FIELD SERVICE BULLETIN

FSB Number: LVCCFSB2006-100
Authors: Darwin Garcia
Date: March 16, 2006
Total No. of Pages: 3
Subject: **V3i Torn K-Flex**
Model Affected: **V3i**
Level of Repair: 2

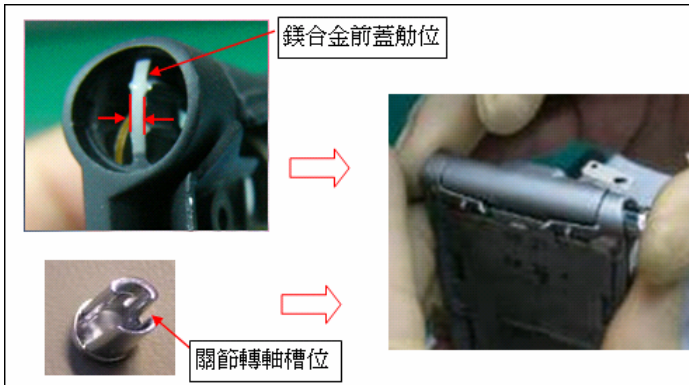
Service has been made aware of a V3i Torn K-Flex issue causing “Display Main - No display” complaints.

Initial analysis found that the tear at the “snake” area occurred during assembly when the K-Flex was pushed through the chrome knuckle hinge.

The factory SOP was change to ensure that operators do not torn K-flex when inserting end cap shaft into flip inner.

- 步驟一 翻蓋內框與前蓋裝配到位, 確保K-flex不被夾住, 如圖1
 Step 1. Keep the flip inner and front housing in the closed position and now snap in the Hsng. End Cap/Shaft(Plating), Shaft(without damaging flex), see figure 1
- 步驟二 檢查關節轉軸外觀, 如圖2
 Step 2. inspect Hsng. End Cap/Shaft, see figure 2
- 步驟三 用鑷子夾取1pc薄銅片, 將銅片插入轉軸縫隙當中, 然後將銅片夾緊貼牢, Step 3. Take 1 pc copper foil, and tuck it into the slot on the shaft, then stick the foil firm surface of the shaft, see figure 3
- 步驟四 裝關節轉軸, 確認突出部分沒有超差, 如圖4
 Step 4. assy Hsng. End Cap/Shaft(Plating), see figure 4
- 步驟五 自檢後流入下一工站。
 Step 5. Make sure no problem, then put qualified workpiece to transport.
